IEEE P802.15
Wireless Personal Area Networks

Project	IEEE P802.15 Working Group for Wireless Personal Area Networks (WPANs)	
Title	TG3 D10 running comment resolutions	
Date Submitted	[21 August, 2002]	
Source	[James P. K. Gilb] [Apparent Technologies] [9921 Carmel Mountain Rd. #247, San Diego, CA 92129]	Voice: [858-538-3903] Fax: [858-538-3903] E-mail: [gilb@ieee.org]
Re:	[]	
Abstract	[This document is a record of comment resolutions for LB17.]	
Purpose	[To provide a record of the comment resolution for LB17.]	
Notice	This document has been prepared to assist the IEEE P802.15. It is offered as a basis for discussion and is not binding on the contributing individual(s) or organization(s). The material in this document is subject to change in form and content after further study. The contributor(s) reserve(s) the right to add, amend or withdraw material contained herein.	
Release	The contributor acknowledges and accepts that this contribution becomes the property of IEEE and may be made publicly available by P802.15.

Figure 16—Source DEV-2 Terminating its stream

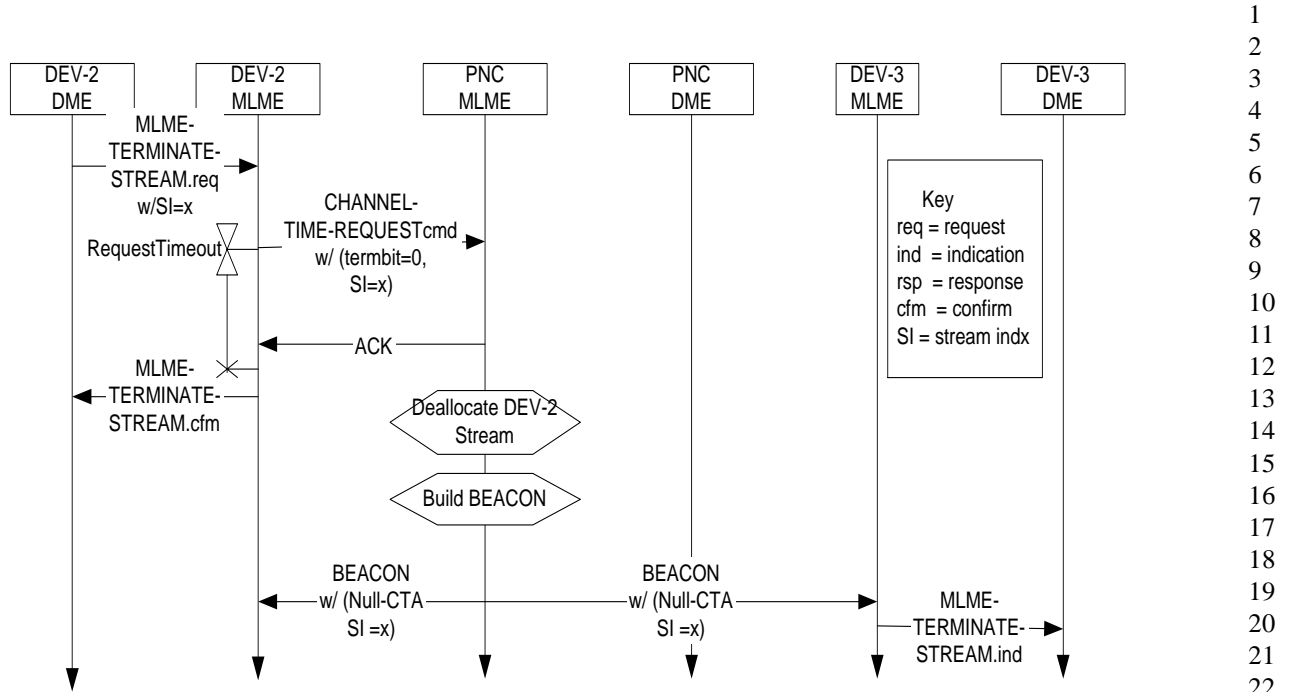
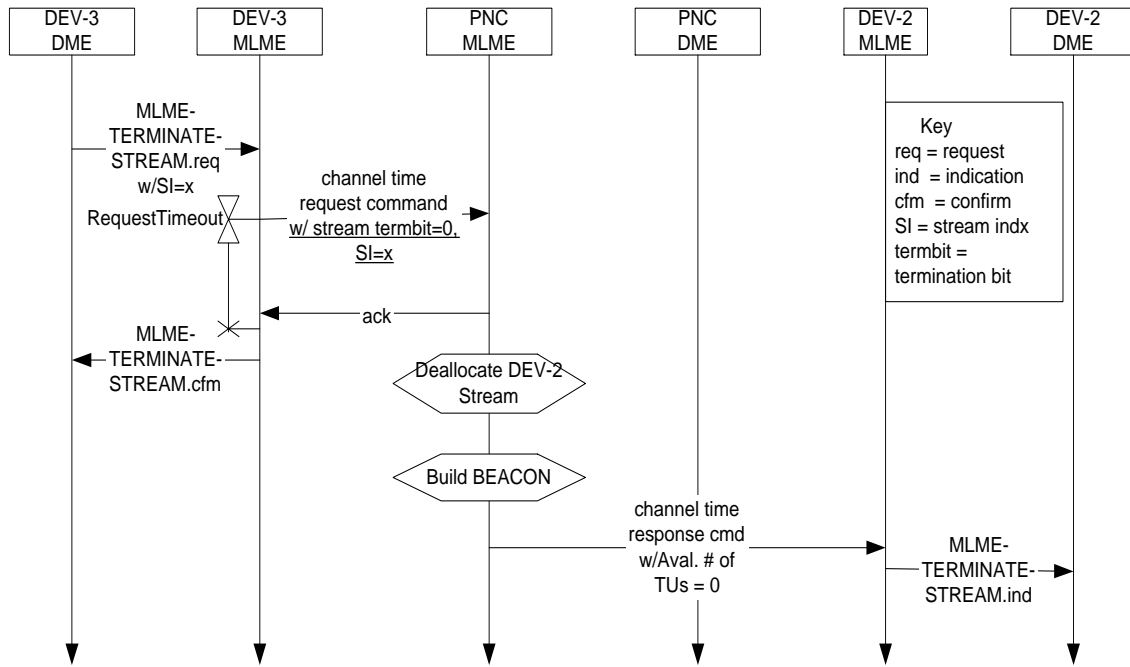
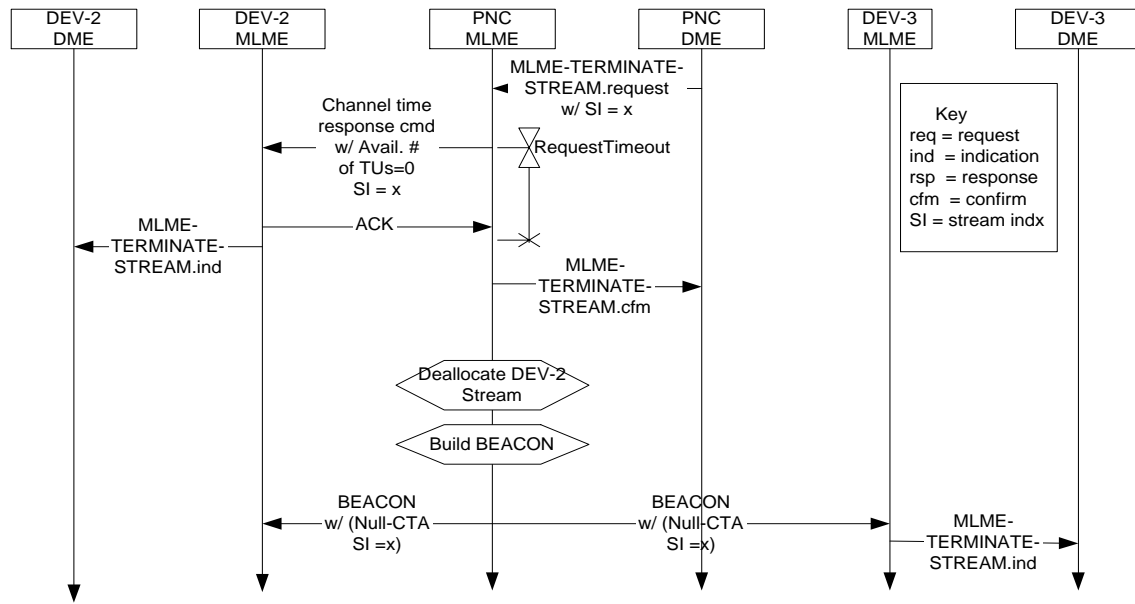
907 (Bain,TR) Grammatical errors and reference to figure 118 is incorrect and does not pertain to text in this section. Consequently, change the paragraph to the following: "In the case where the PNC wishes to terminate the stream, it shall notify the originating DEV and the target DEV via the next periodic beacon that the CTAs assigned to the indicated stream index are set to a null CTA value for aMinBeaconInfoRepeat duration." Suggest reject pending acceptance of CID 364

155 (Heberling, TR) KO> MLME-TERMINATE-STREAM.indication not used for target, only source. Consequently, for clause 6.3.14.10 MLME_TERMINATION_CTA.indication <change from> This primitive is used to inform the target DEV that channel time that was previously allocated is no longer present in the most recently received beacon. <to> This primitive is used to inform the source DEV that channel time that was previously allocated is no longer present in the most recently received beacon. **Suggest accept in principle**, “Change 6.3.14.10 as indicated in 02/273r12”

Resolution is to reject, "Figure 118 has been removed, a new termination procedure in 02/273r13 describes with correct MSCs the procedure."

Figure 21—MSC for the initiating of a neighbor piconet.

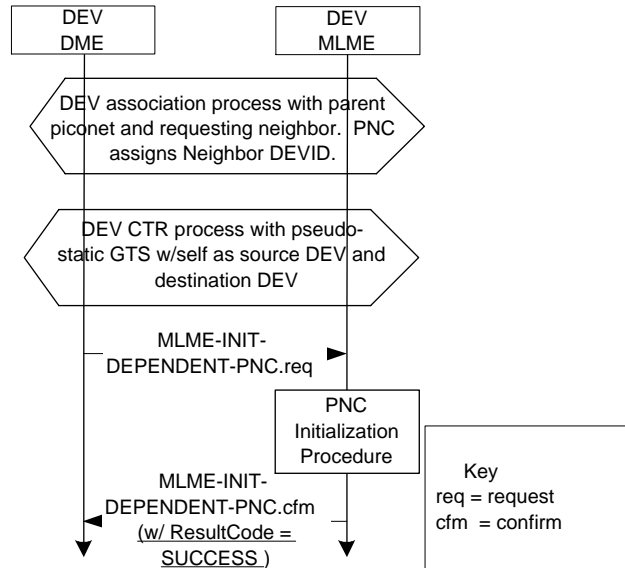
179 (Heberling, TR) - Figure 98 should be replaced with a proper MSC of the required protocol needed to establish a neighbor piconet. Replace figure 98 with a proper MSC. **Suggest accept** - An MSC for neighbor piconet initialization is included below. It needs twiddling to get the vertical lines to not show in the hex process blocks. Also, although consistent with other similar diagrams, this MSC seems to need the first beacon of the neighbor PNC shown.

Accept in principle, “Accept suggested resolution but add a line at the bottom that shows the first beacon being sent. Also add after the sentence that says ‘The MSC for the initiation a neighbor piconet is illustrated in Figure 21.’ the following sentence, ‘The association and channel time request processes are defined in xref and xref, respectively.’”

Figure 22—MSC for the creating a child piconet.

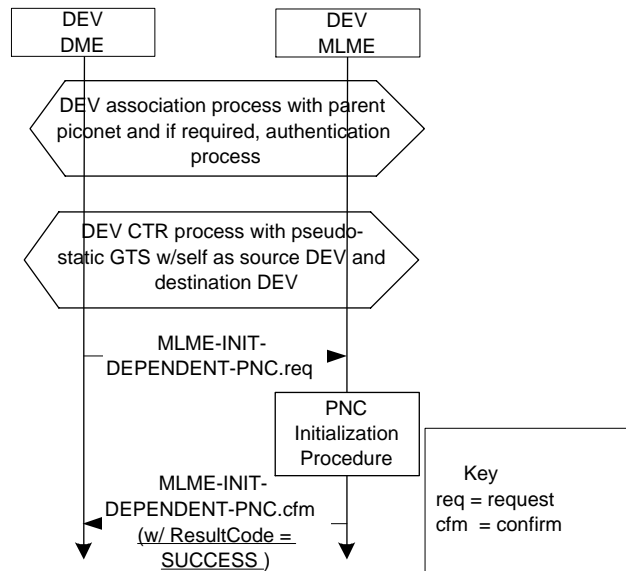
177 (Heberling, TR) - Figure 96 should be replaced with a proper MSC of the required protocol needed to establish a child piconet. Replace figure 96 with a proper MSC. **Suggest accept** ‘An MSC for child piconet initialization is included below. It needs twiddling to get the vertical lines to not show in the hex process blocks. Also, although consistent with other similar diagrams, this MSC seems to need the first beacon of the child PNC shown.

Accept suggested resolution but add a line at the bottom that shows the first beacon being sent. Also add after the sentence that says ‘The MSC for creating a child piconet is illustrated in Figure 22.’ the following sentence, ‘The association and channel time request processes are defined in xref and xref, respectively.’

Figure 23—MSC for a approved asynchronous channel time request

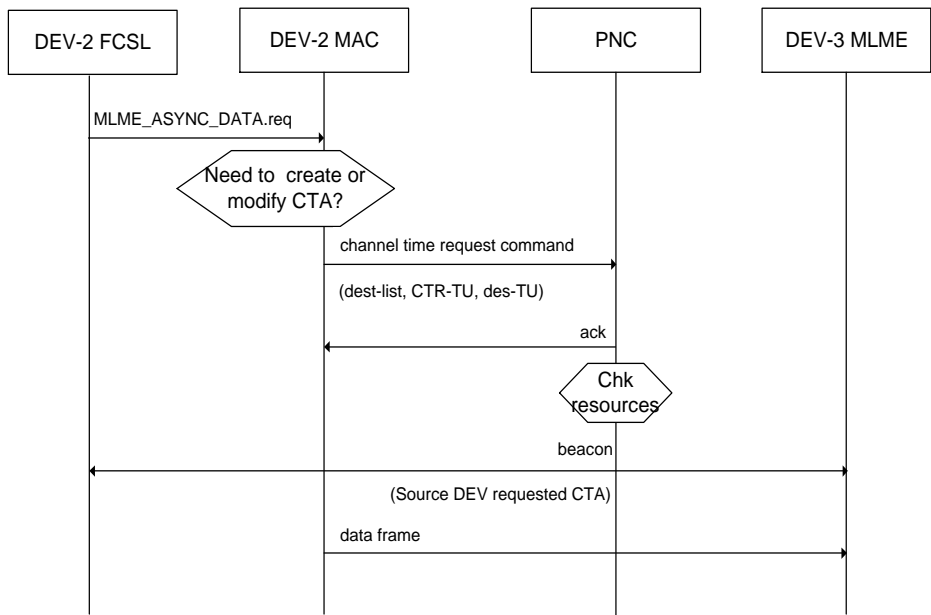
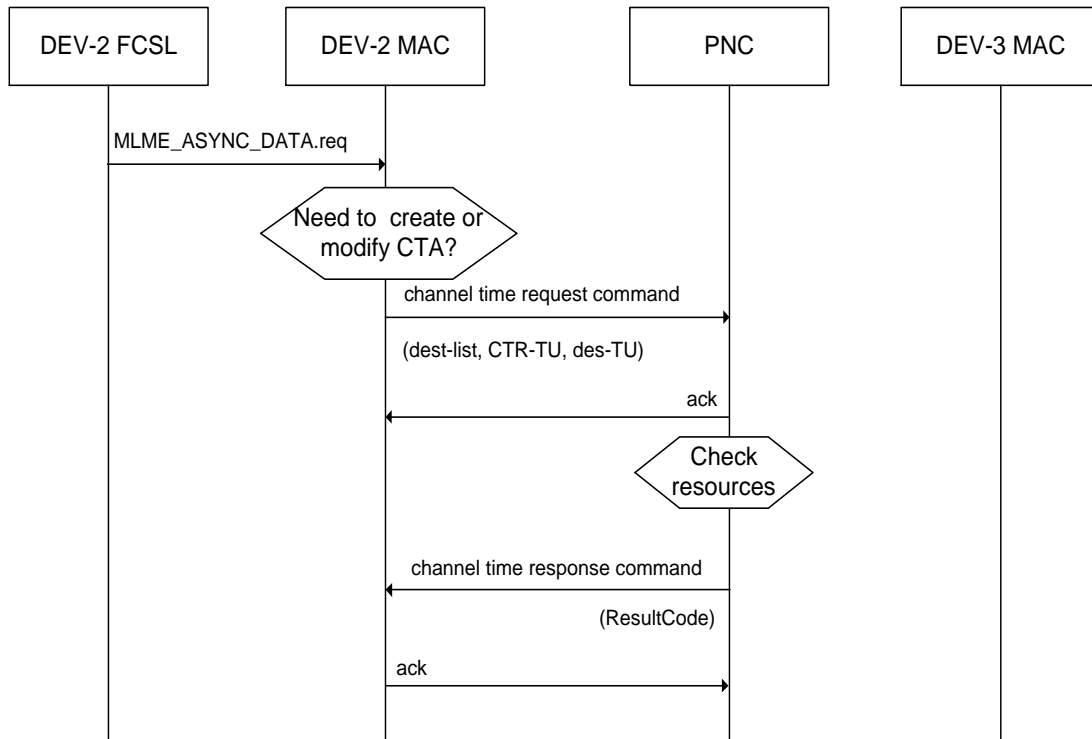
327 (Heberling, TR) Figure 119 is a flawed MSC of the Asynchronous channel time reservation process and data frame exchange. Consequently, delete the current MSC from this section of clause 8.5.2.1 and replace it with 02r0P802-15_TG3-Asynch-channel-time-allocation.eps. **Suggest accept**.

<Page 182, Figure 119> – MSC for reserving asynchronous data channel time. Discussed earlier, new MSC is below (needs work to match the other MSCs in the clause.):
